## Technical Memorandum

Subject: Response to MEDEP Comments  
Phase 14 Solid Waste Permit Application - Volume 1  
Crossroads Landfill, Norridgewock, Maine

**Figure 3 – Updated Aerial Image of Phase 14 Vicinity**

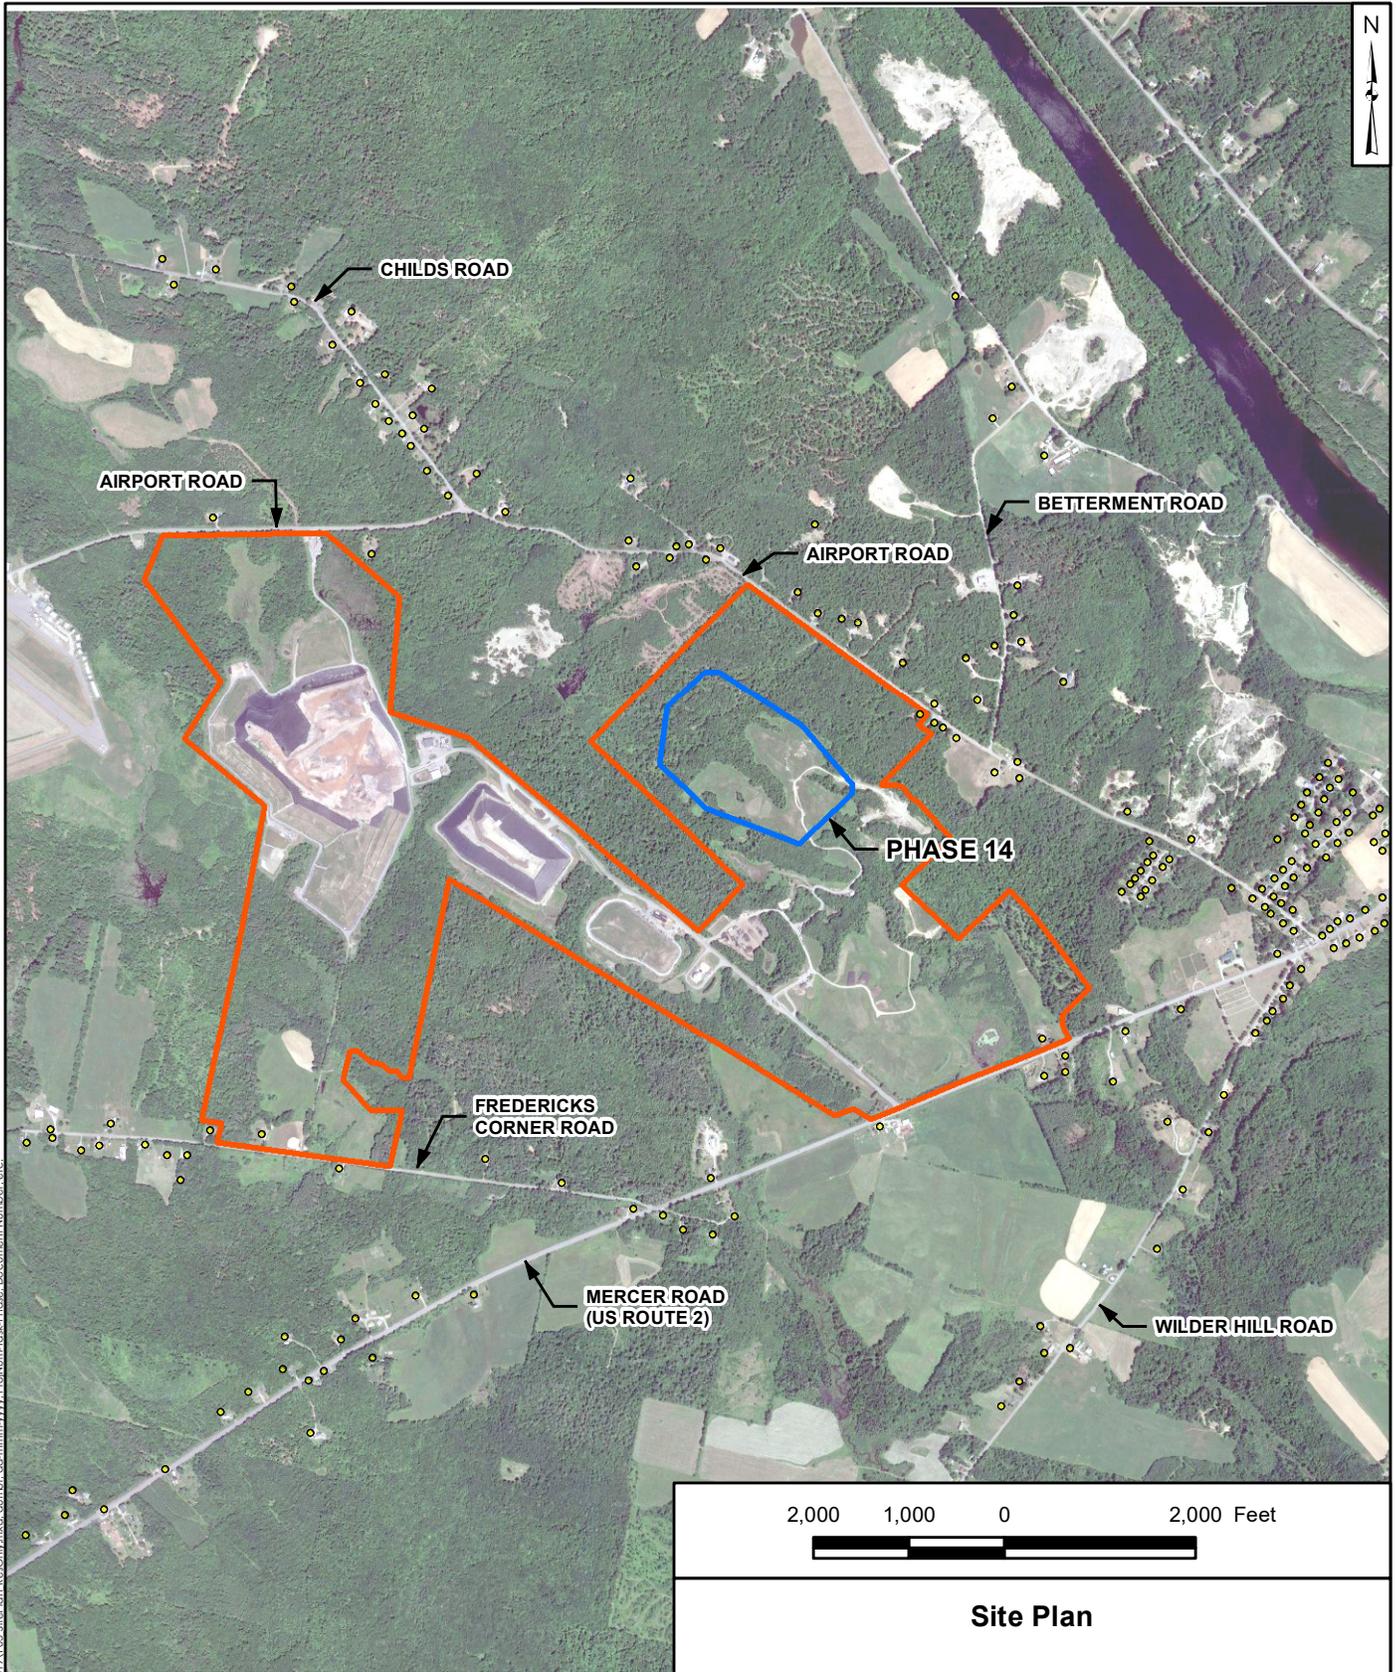
e. *Appendix 7C, Figure 3. The yellow boxes indicating residences or buildings do not seem to match up with structures in aerial images. For example, there are no residences/structures on Airport Road*

*northeast of the proposed landfill (where the “Airport Road” label is) or in the area to the southwest, along Mercer Road. Please check that the residence/structures are accurately located. Please center the landfill in this figure and include more residences/structures to the east and north.*

**Response to Comment 7e.** Figure 3 has been updated to show the locations of residences on Airport Road and Mercer Road as recently generated by WMDSM’s surveyor (Boynton & Pickett) from a detailed overlay with the aerial image. And as requested, the coverage of Figure 3 has been adjusted to show the Phase 14 footprint centered on the page with additional residences west of the Kennebec River now identified. The labels for the roads have been shifted to clarify that no residences are obscured by the labels. The updated Figure 3 is attached to this RTC technical memorandum as ATTACHMENT RTC#7e-1.

**Photographs from Vantage Points taken in Winter**

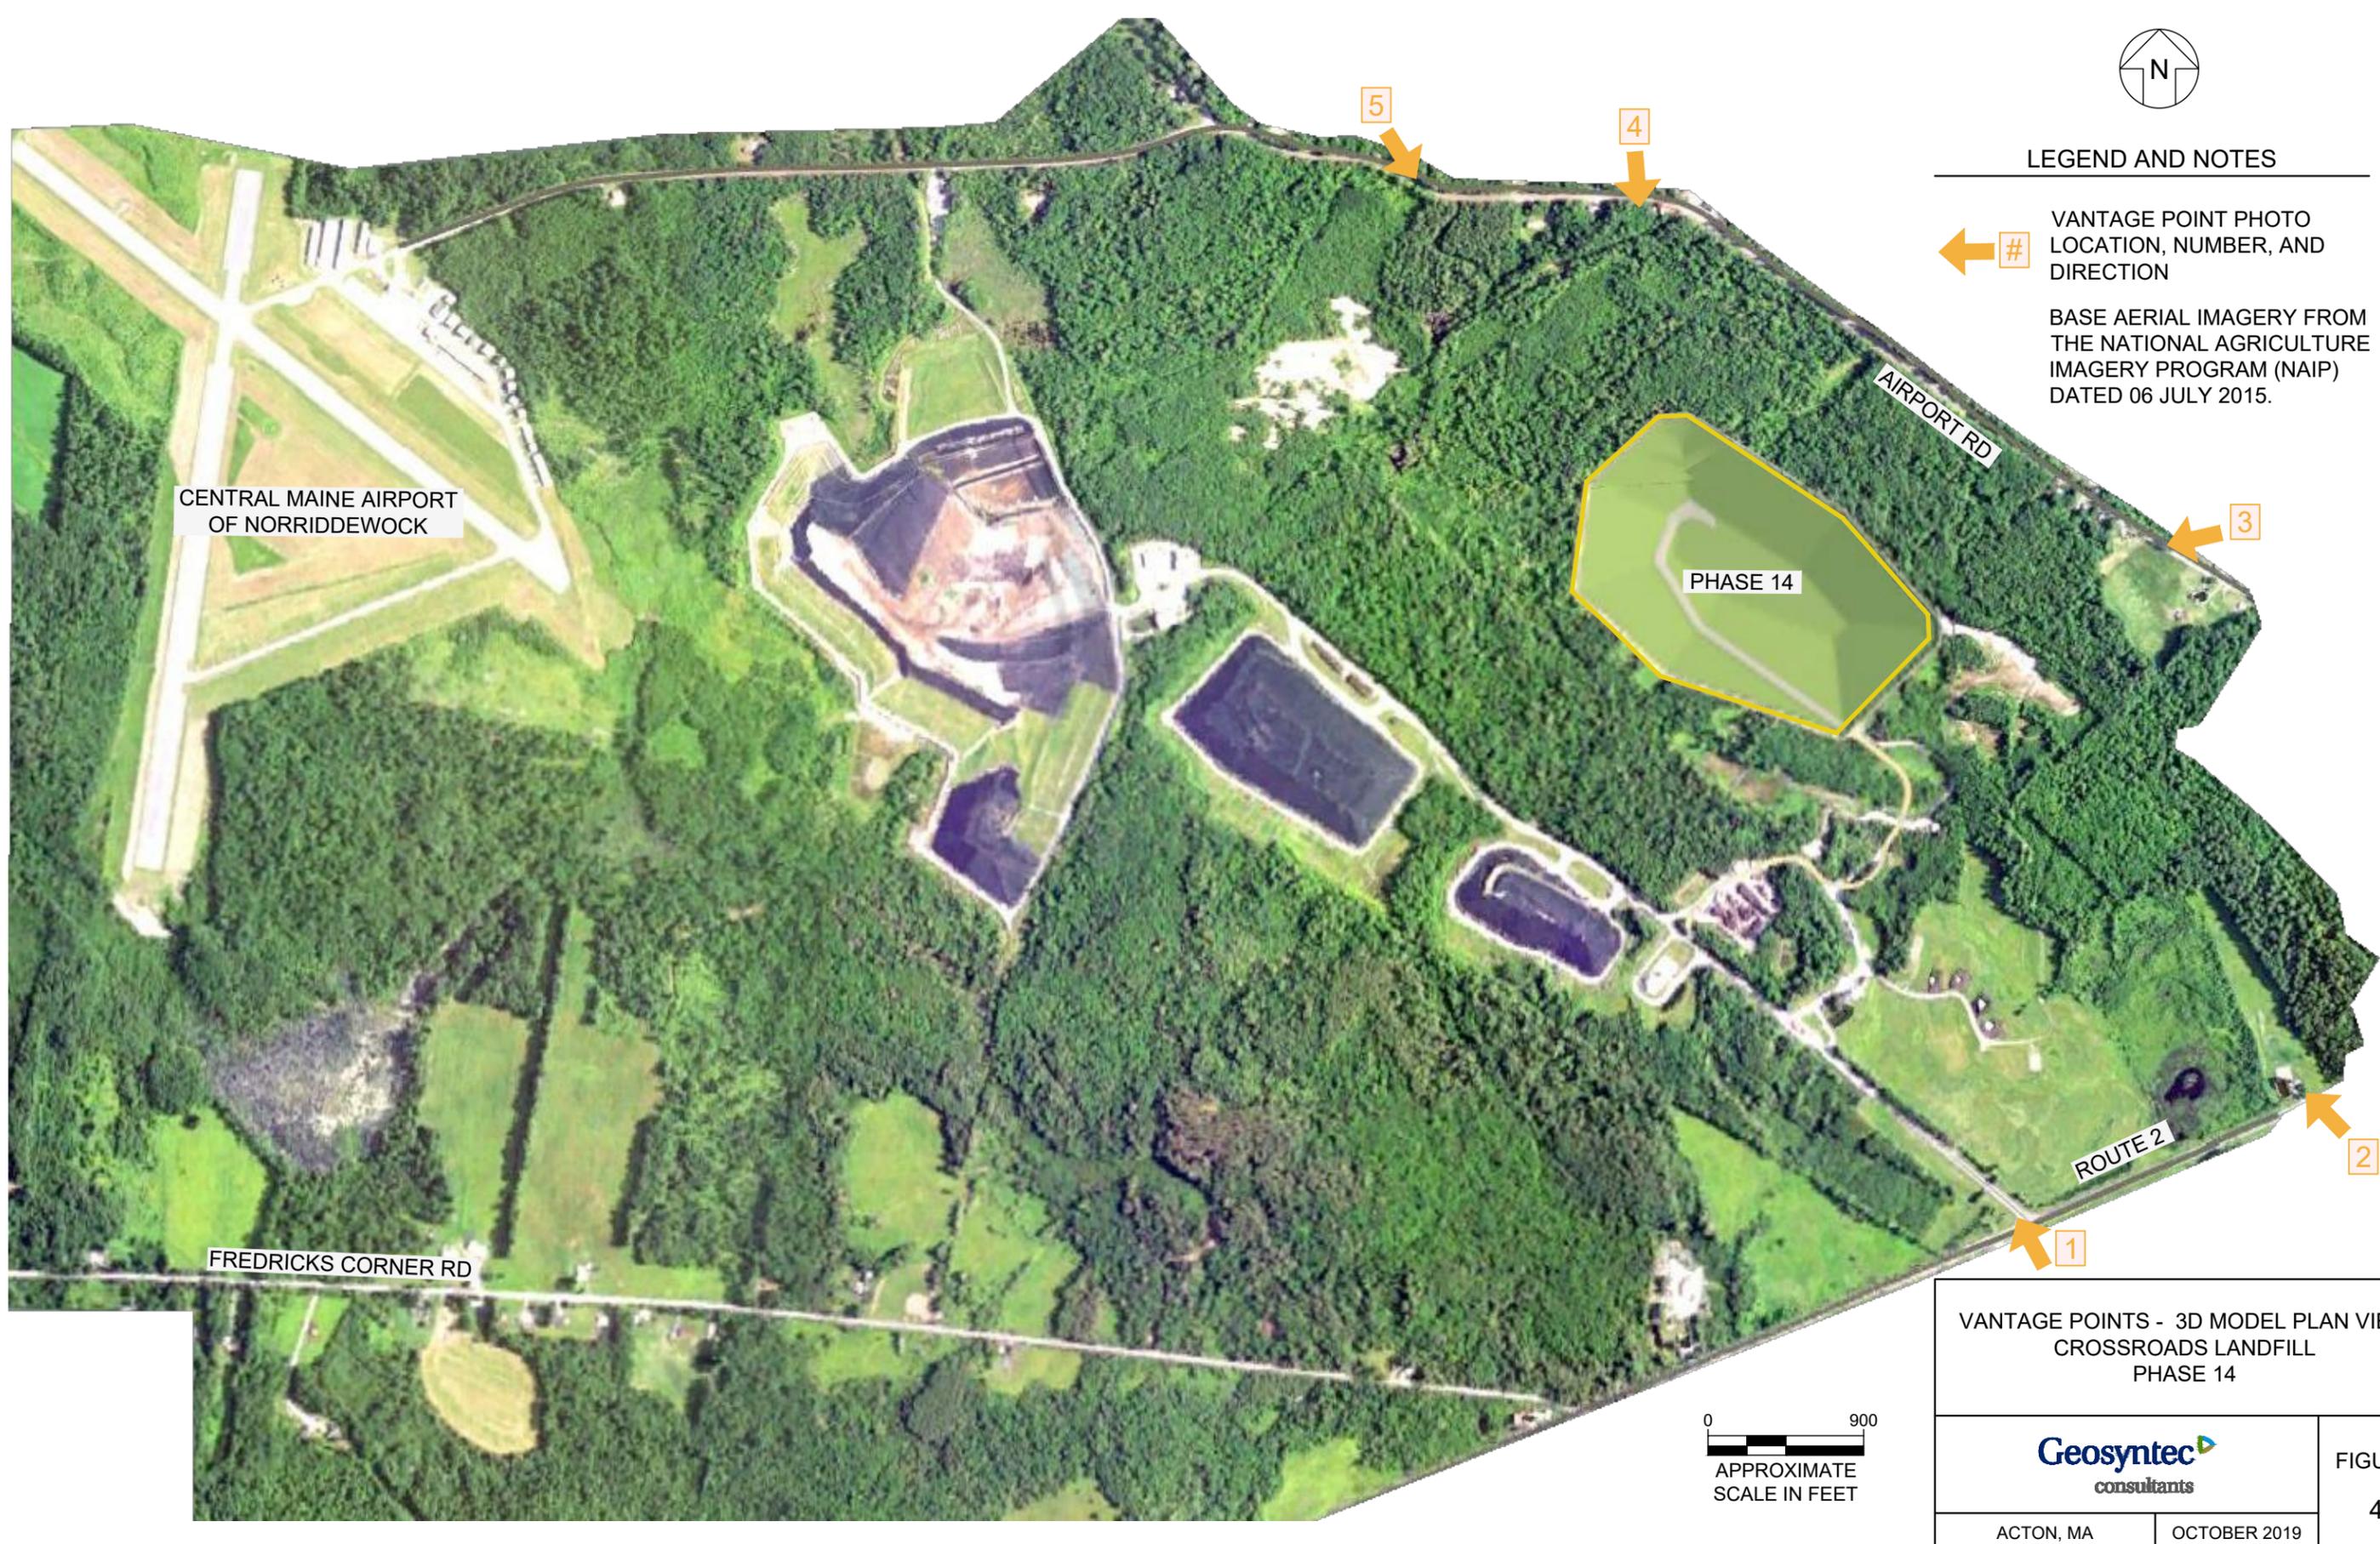
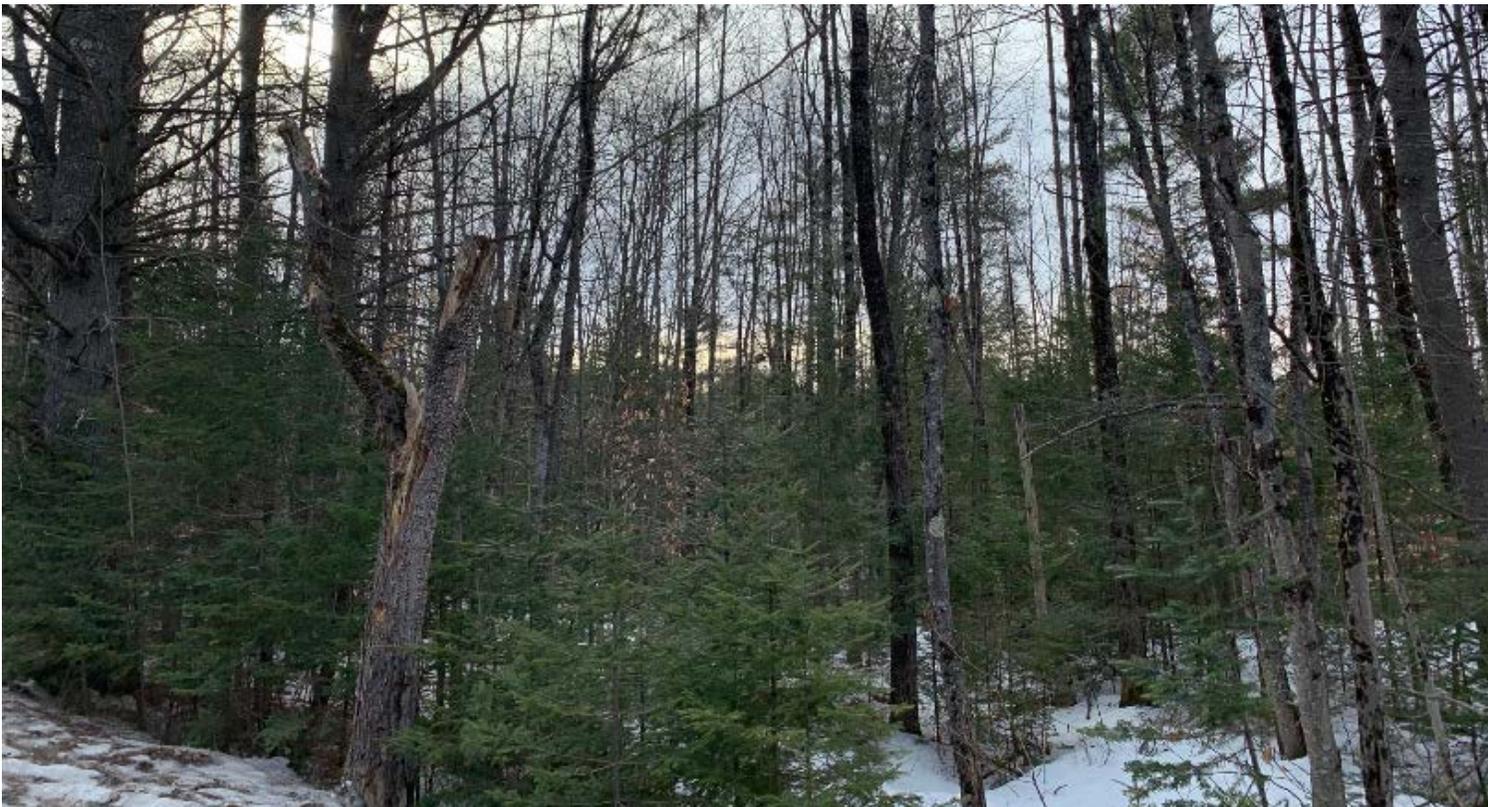
*f. Appendix 7C, 2.2 Study Area Characteristics, Vegetation (page 3). Please include a discussion of the visibility of the landfill in the winter compared to in the summer. Were field observations obtained during worst-case times of the year?*

**Response to Comment 7f.** Photographs were recently obtained in March 2020 from the five vantage points in the visual assessment report. Comparison of these photographs (attached to this RTC letter as ATTACHMENT RTC#7f-1) to the photographs in the October 2019 Visual Assessment report confirms the vegetation in the Phase 14 buffer zone consists largely of densely wooded areas with a high percentage of evergreen/conifer trees, and as such, the visual screening provided by the vegetation in the winter is not significantly different than provided during summer months.

3D MODEL VIEW FROM VANTAGE POINT LOCATION #6 CROSSROADS LANDFILL PHASE 14

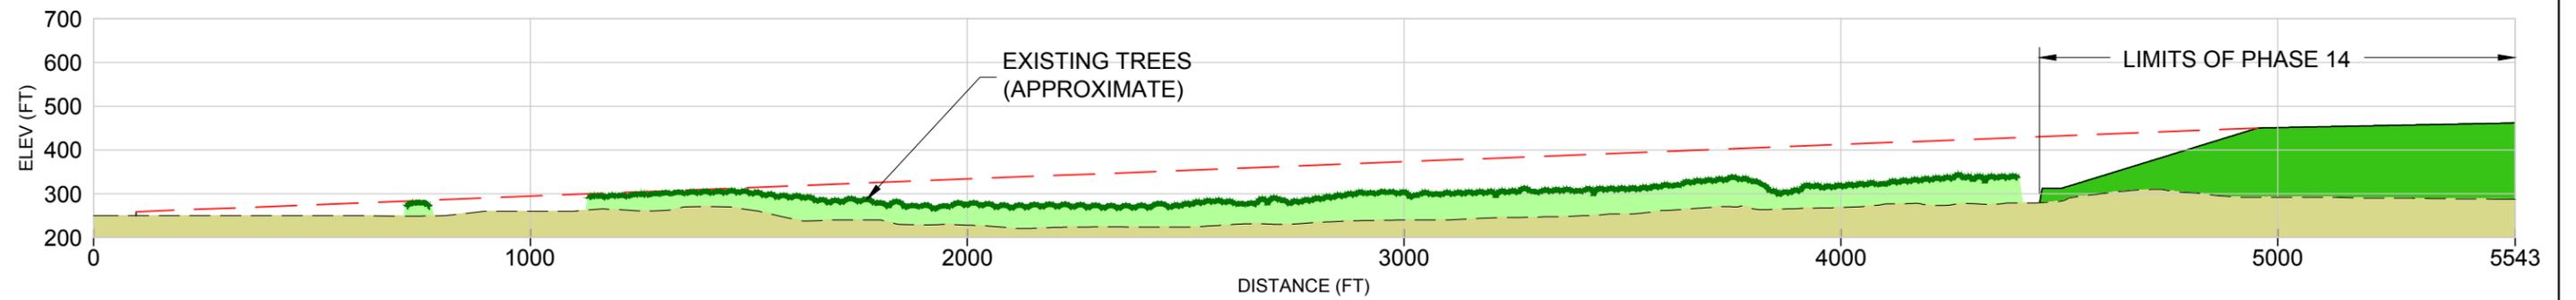
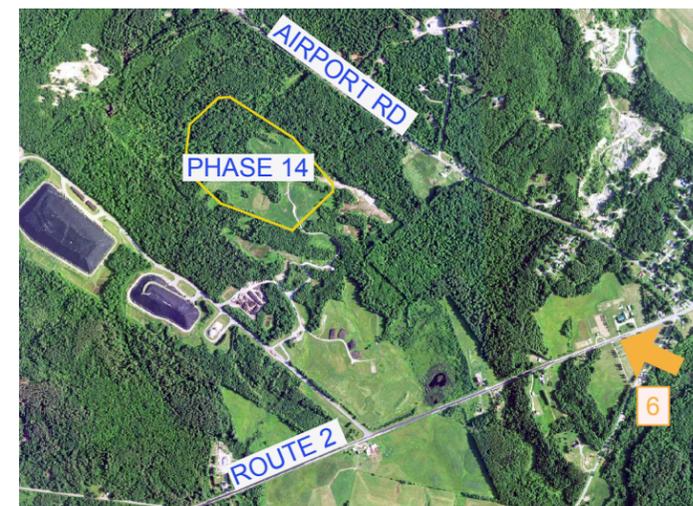
*g. Appendix 7C, 3.2 Visual Characteristics of Phase 14 Development, Post-Closure Period, second paragraph (page 6). The vantage points chosen for evaluation are appropriate, but please also evaluate the view from the school/cemetery area.*

**Response to Comment 7g.** Pursuant to this MEDEP comment, an evaluation of the potential for Phase 14 to be visible from the school/cemetery area along Route 2 has been performed using the same methods and modeling software used in the October 2019 Visual Impact Assessment Report. The location of photographs obtained from the additional Vantage Point 6 is shown on Revised Figure 4 attached to this RTC technical memorandum as ATTACHMENT RTC#7g-1. AutoDesk® Infracore® 3-dimensional software was used to show the final configuration of the landfill on the photograph from Vantage Point 6. As shown, Phase 14 will not be visible from this area until the final period of operations, during which time the landfill will be incrementally covered with a vegetated cover system that blends in visually with the surroundings. It is noted too that this depiction of visibility was conducted using a photograph obtained in March 2020 (during winter), and as noted in the October 2019 report much of the vegetation is expected to continue growing and providing additional visual screening over the approximately 15 years before Phase 14 approaches final height.
